# SUNDRY NOTICES AND REPORTS ON WELLS

6. If Indian, Allottee or Tribe Name		
SUBMIT IN TRIPLICATE - Other instructions on reverse side.					7. If Unit or CA/Agreement, Name and/or No		
1. Type of Well	☐ Gas Well ☐ Oth		8. Well Name and No. CROW FLATS 14 FEDERAL 3H				
2 Name of Opera			9. API Well No. 30-015-36350-00-X1				
3a. Address	CITY, OK 73154	1-0496	3b. Phone No. (include area code Ph: 405-767-4275			Exploratory	
		T., R., M., or Survey Description			11. County or Parish, and State		
Sec 14 T16S R28E SESE 660FSL 200FEL			NOV 26 2008	BDDY COUN		Y, NM	
OCD-ARTESIA							
1	2. CHECK APPI	ROPRIATE BOX(ES) TO	O INDICATE NATURE OF 1	NOTICE, REP	PORT, OR OTHE	R DATA	
TYPE OF S	UBMISSION		TYPE OF ACTION				
Notice of □	ntent	☐ Acidize	Acidize Deepen Prod		uction (Start/Resume)		
☐ Subsequer		☐ Alter Casing	☐ Fracture Treat	☐ Reclamati		☐ Well Integrity	
_		Casing Repair	□ New Construction	Recomple		Other Change to Original	
☐ Final Abandonment Notice		Change Plans	Plug and Abandon	☐ Temporar		PD

Proposed Well Schematic (drilling)

Crow Flats 14 Federal 3H 30-015-36350 Chesapeake Operating, Inc. November 20, 2008 Conditions of Approval

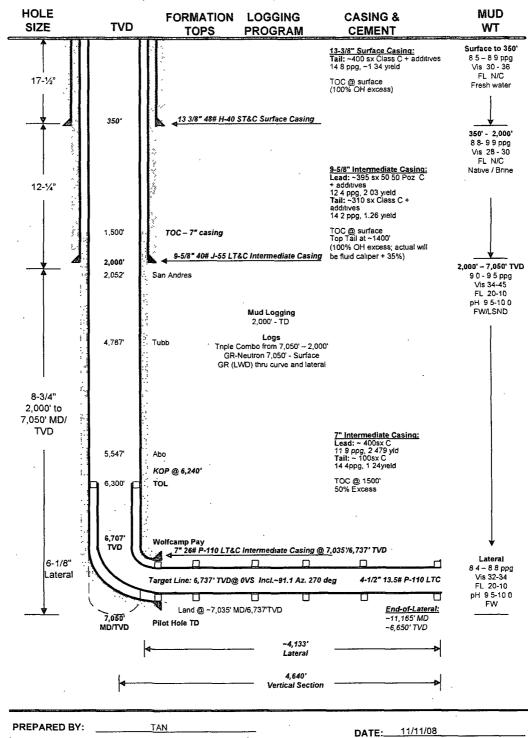
- 1. Pressure test for casing should be 1550 psi per Onshore Order 2.
- 2. Operator shall provide method of verification for cement top on 7" casing.
- 3. Sundry incorrect on TVD for 4 ½" casing actual per schematic is 6650' TVD not 6050' TVD.
